# 2. CYCLING IN ASHTEAD

### 1. Wells to Craddocks Avenue

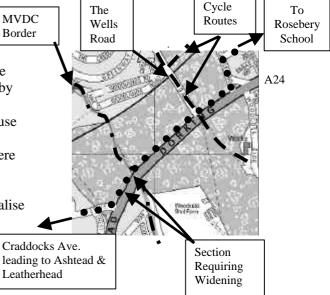
The footpath alongside the A24 between The Wells Road and Craddocks Avenue is used by many cyclists, particularly Therfield and Rosebery School pupils, to avoid having to use the busy main road. This use only causes problems to pedestrians at the south end where the path narrows to about 1 metre wide.

**Suggestion**: Widen this section of the path and legalise its use by cyclists. Also provide formalised points where cyclists can rejoin The Wells Road and Craddocks Ave at each end.

#### 2. Craddocks Avenue Chicanes

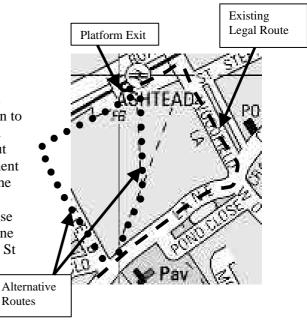
The cycle bypasses constructed around the chicanes in Craddocks Ave are poorly designed and are little used by cyclists. The design faults are many, the worst being the merges back onto the carriageway, which are unsafely designed and located.

**Suggestion:** Either carry out extensive improvements to bring the chicane bypasses up to standard, or remove them altogether. Cars are happy to follow cyclists through other restricted width sections along the road, so why not at the chicanes? It would also help to slow traffic and so improve safety.
